Appl. No.: 10/647,488
Amdt. Dated August 23, 2006
Reply to Office Action of February 23, 2006

Amendments to the Drawings

FIGURE 1

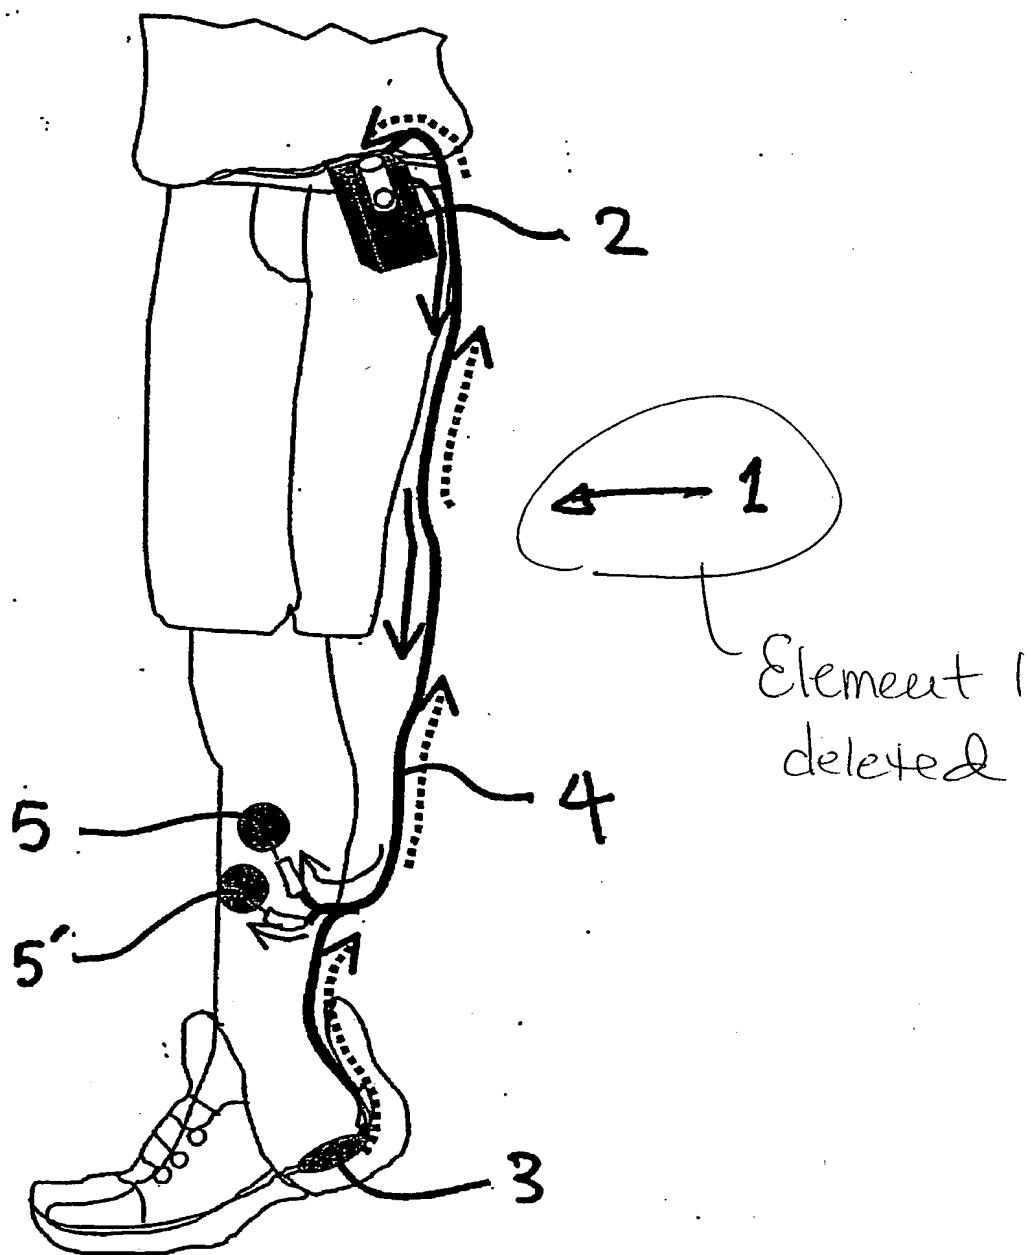
The attached one (1) sheet of drawings that includes Figure 1 will replace the sheet of drawings as originally filed. On the one (1) enclosed replacement sheet that includes Figure 1, element 1 has been deleted.

Enclosed is one (1) Replacement Sheet including Figure 1, which is amended to delete element 1. An Annotated Drawing Sheet is included with this submission.
